RE: UWMC Northwest Development Advisory Committee (DAC) Comments and Recommendations Concerning the UWMC Northwest Hospital Major Institutions Master Plan (MIMP).

UNIVERSITY OF WASHINGTON MEDICAL CENTER, NORTHWEST HOSPITAL MAJOR INSTITUTIONS MASTER PLAN

DEVELOPMENT ADVISORY COMMITTEE Final Report and Recommendations

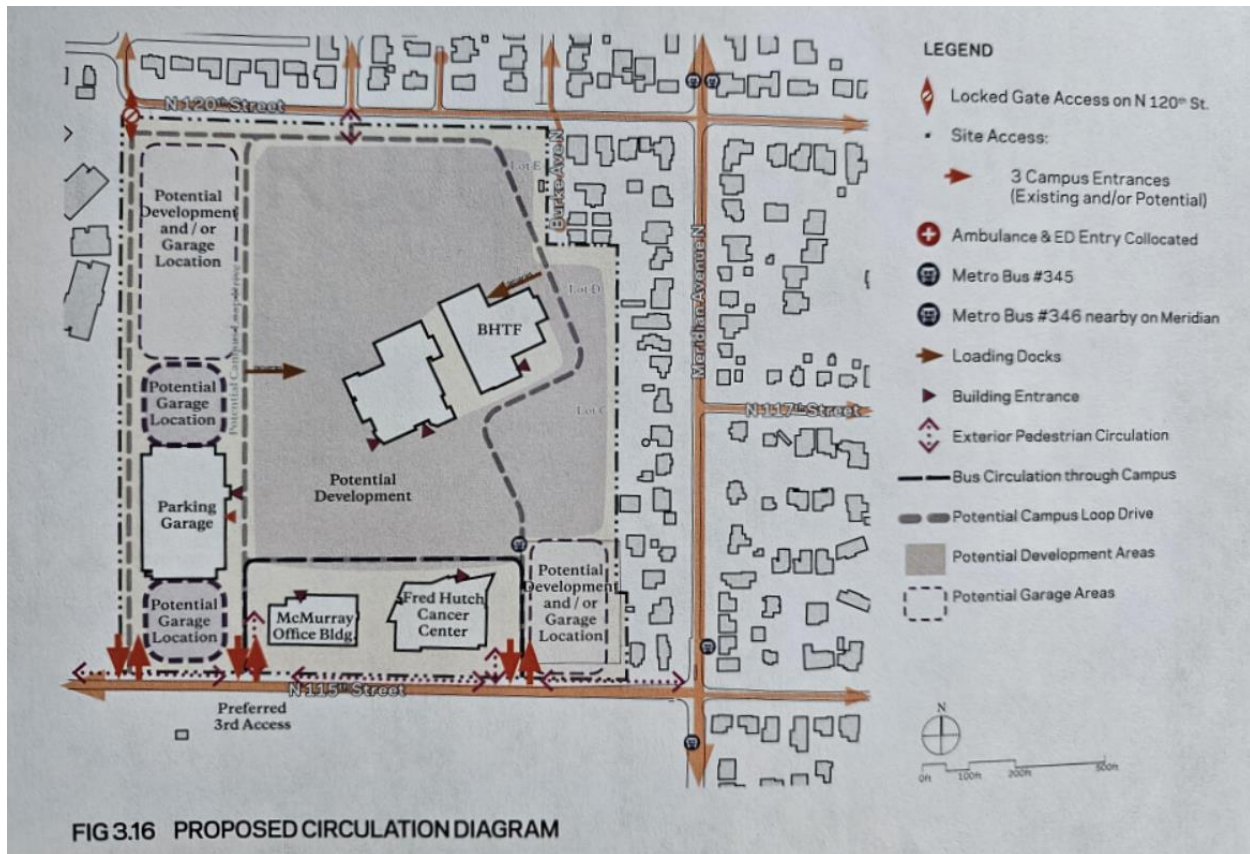
Recommendation Comment #2

The DAC recommends that SDCI confirm that the central utility plant within the final MIMP and EIS has strong parameters to control the impact of potential air quality, air-borne pollutants and noise to ensure that the nearby residents are protected.

In person and Remote Meeting, via WebEx – video recording is available on request.

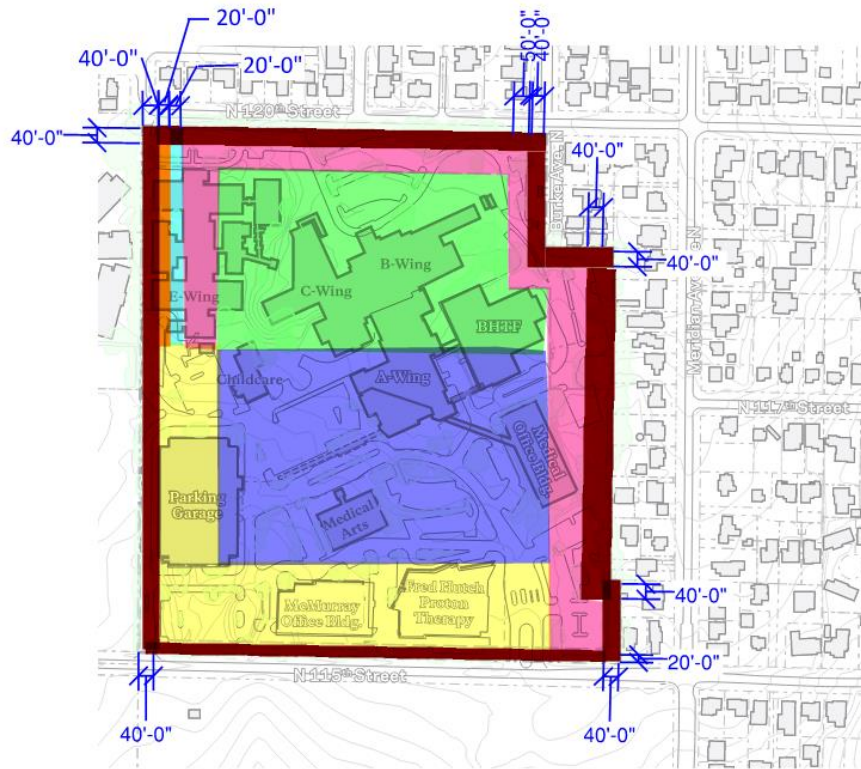
Add an additional tiered height limit on the west side of the property adjacent to existing Stendall Place homes, as shown in below figure, at 40' setback, 20' at 30' high, 20' at 48' high. Approximately aligned with current E-Wing building footprint.

Change the 145' height to 120' and extend the 120' area to the area north to just north of the A-wing leaving the widths the same. Please see the figure below.

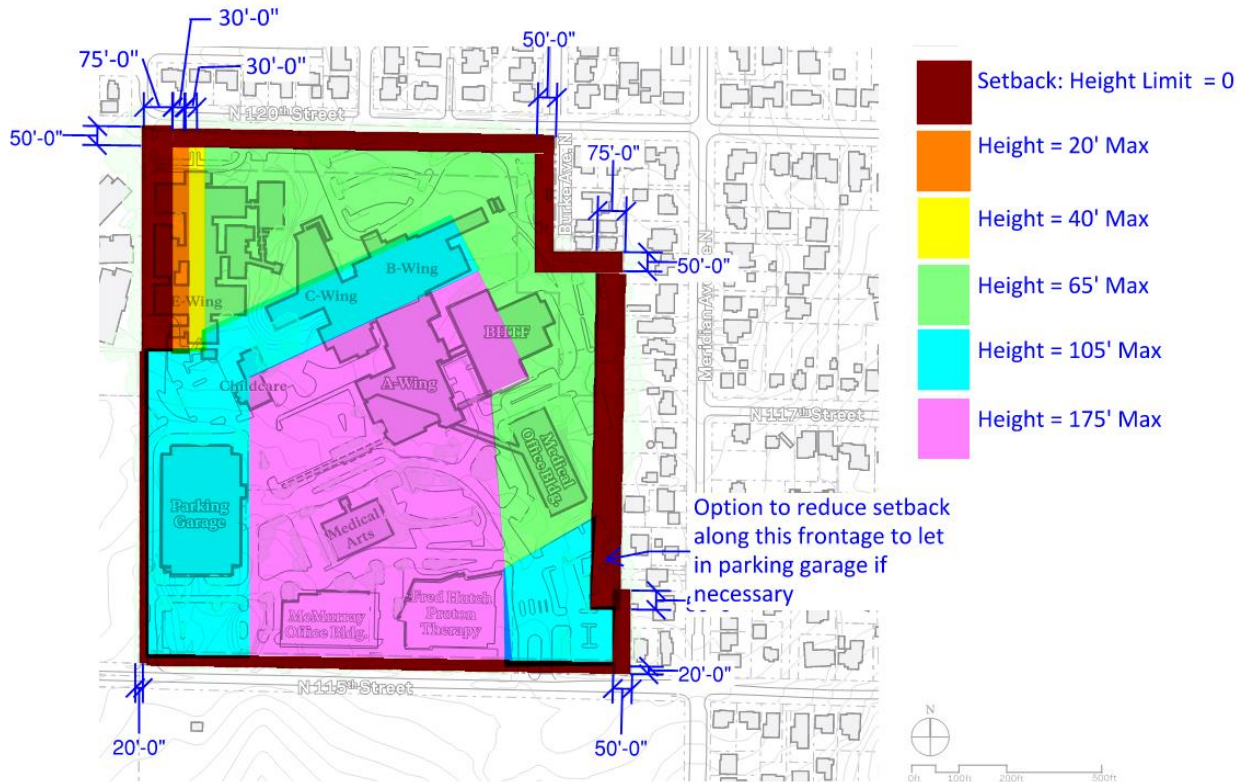
- Figure 3.7 / 3.12 - We recommend the following changes to the setbacks (see diagram below):
 - 75' on the north half of the west Property Line (adjacent to residential parcels)
 - 75' on the central-east Property Line (where directly adjacent to residential parcels)
 - 20' on the south half of the west Property Line (adjacent to cemetery)
 - 50' on north, northeast and southeast Property Lines (where not directly adjacent to existing residential structures))
 - 20' on the south Property Line
 - Note: Setbacks may include drive-aisles, parking, etc. as long as the existing vegetation remains intact (including trees to the drip line and root structure), except along the west Property Line within the 75'-setback zone. At that location, vehicular traffic must be limited to Fire Lane Only, no other personal or commercial vehicles.

- Figure 3.7-8 / 3.12-13 - We recommend changes to the height limits (see diagram below):
 - Reduce 175' height district to central/south area of campus
 - Provide conditioned limits adjacent to residential parcels with existing structures within 20' of property line
 - Note: Existing structures within the revised districts may be considered legal nonconforming (“grandfathered”) conditions that may remain in perpetuity as long as no significant building additions or modifications are constructed. Regular maintenance, adaptive reuse, and buildings systems upgrades are acceptable and encouraged, particularly at E-wing.
